RE: The Department of Conservation's Draft Environmental Impact Report (DEIR) for Well Stimulation in California

On behalf of the Natural Resources Defense Council (NRDC), Center for Biological Diversity (CBD), Sierra Club, Los Angeles Waterkeeper, and our millions of members and activists, we submit the following comments on the Department of Conservation's, through its Division of Oil, Gas and Geothermal Resources (DOGGR), Draft Environmental Impact Report (DEIR) for Well Stimulation in California (the Project) prepared pursuant to the California Environmental Quality Act (CEQA).

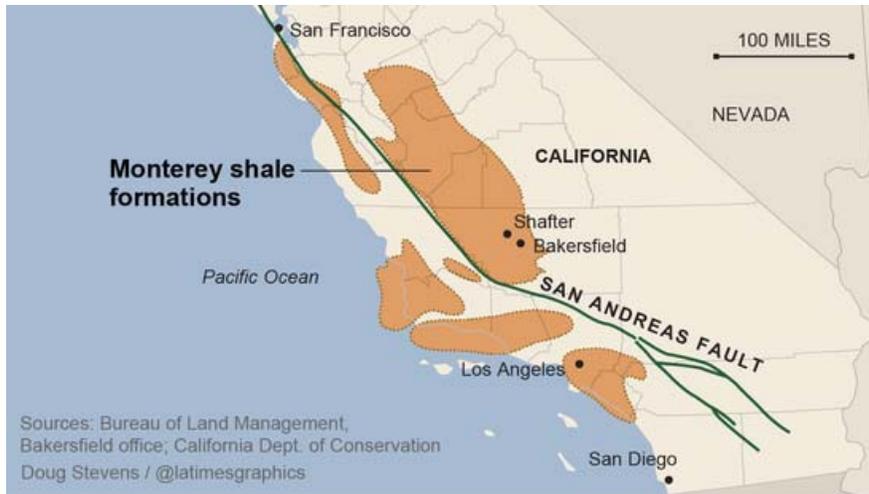
For purposes of the DEIR, DOGGR partitioned the State into six study regions. These study regions follow the boundaries of DOGGR's six administrative Districts. The stated purpose of subdividing the State was to grapple with California's "diversity of environmental attributes," but the boundaries of the study regions are set by political, not environmental, parameters. Instead of permitting an analysis that considers similar ecosystems or is done by impacted watersheds, for example, the study regions serve to splice and downplay impacts. This improper piecemealing masks impacts and impairs review.

Furthermore, Senate Bill 4 and Public Resources Code Section 3161(b)(3) require this EIR to evaluate well stimulation treatments throughout the State of California. This EIR, however, fails to do that. Instead it excludes "portions of California that have not been developed for oil and gas production historically," and areas "not reasonably projected to be developed for oil and gas production in the future because they do not contain hydrocarbon reserves that could be economically produced."²¹ In total, it excludes 27 of California's 58 counties or approximately 43 percent of California's total land mass.
